## **A38 DERBY JUNCTIONS SCHEME—LITTLE EATON JUNCTION. APPLICATION FOR DEVELOPMENT CONSENT ORDER.**

WRITTEN REPRESENTATIONS BY BREADSALL PARISH COUNCIL TO THE  
EXAMINING AUTHORITY

### **Part 1. Selection of the preferred route**

**Figure 5/2: Layouts of the Alternative Options received in 2016 in relation to A38/A61 Little Eaton Junction**

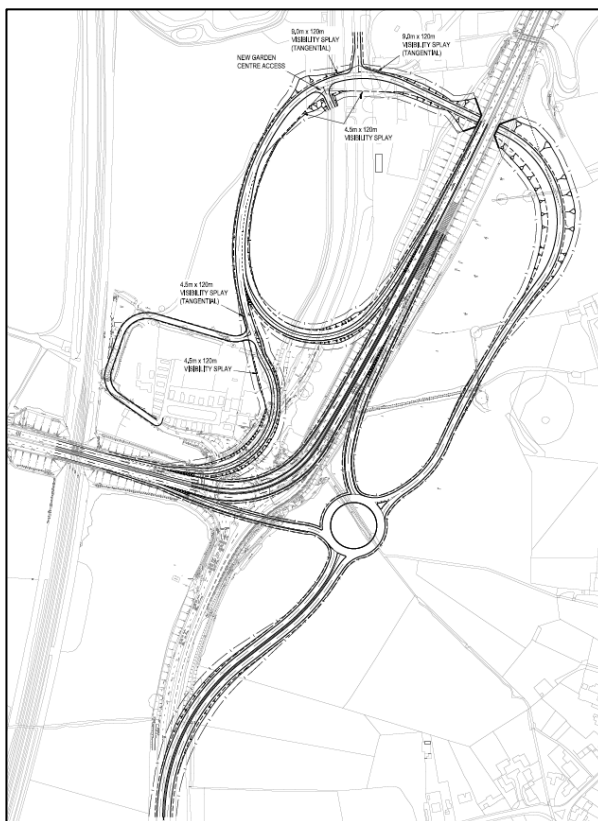
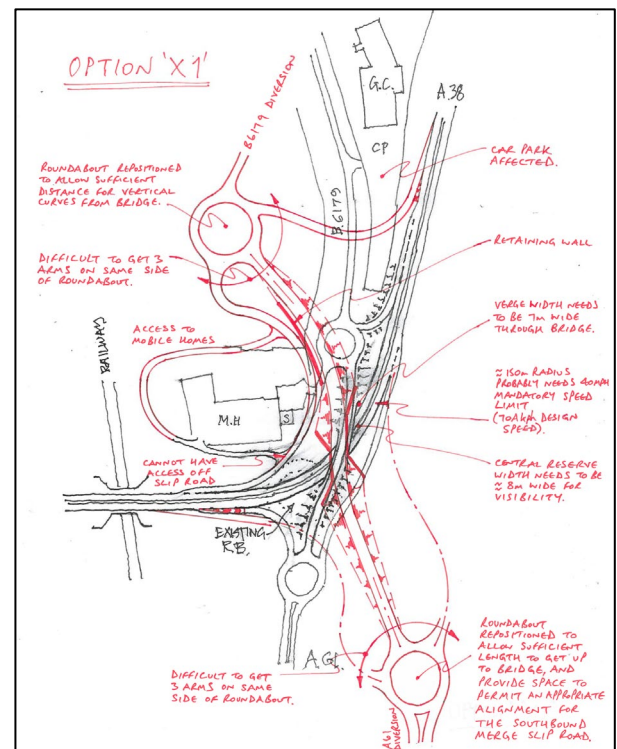
It was true that Options 1 and 2 would adversely affect adjoining property but there were potential ways of overcoming these issues and it appears that HA simply abandoned Options 1 and 2 without making any attempt whatsoever to address adverse effects on adjoining property. As late as 2016 HE admitted that they had no record of approaching a single one of the affected tenants or landowners. HE had thus wasted some 13 years during which they could have attempted to overcome issues related to property north of the existing junction. In practice there were several measures which HE could have taken including the following: -

The Action Group finally put forward an Option X1 which involved keeping the A38 on its present alignment and replacing the roundabout with a flyover for the A61. This was again rejected out of hand by HE and never pursued in any detail.

- 5.4.33 The Action Group's aim in developing Options 2A and 2B was to provide a route which was further from Breadsall but without excessive impacts on the communities around Little Eaton. The options also had the effect of enabling the scheme to provide a higher design speed due to the improved alignment.

- 5.4.34 However, Options 2A and 2B would require the purchase of 3<sup>rd</sup> party land in order to mitigate for the loss of parking for the garden centre. As this additional land is not an integral part of the main scheme, its purchase is not possible under Highways England's powers for Compulsory Purchase set out in the Planning Act 2008. The powers do not allow the compulsory acquisition of land for the purpose of providing replacement facilities for a local landowner and the use of compulsory acquisition powers for this purpose would be considered an abuse of Highways England's powers and as such, would be indefensible if challenged.
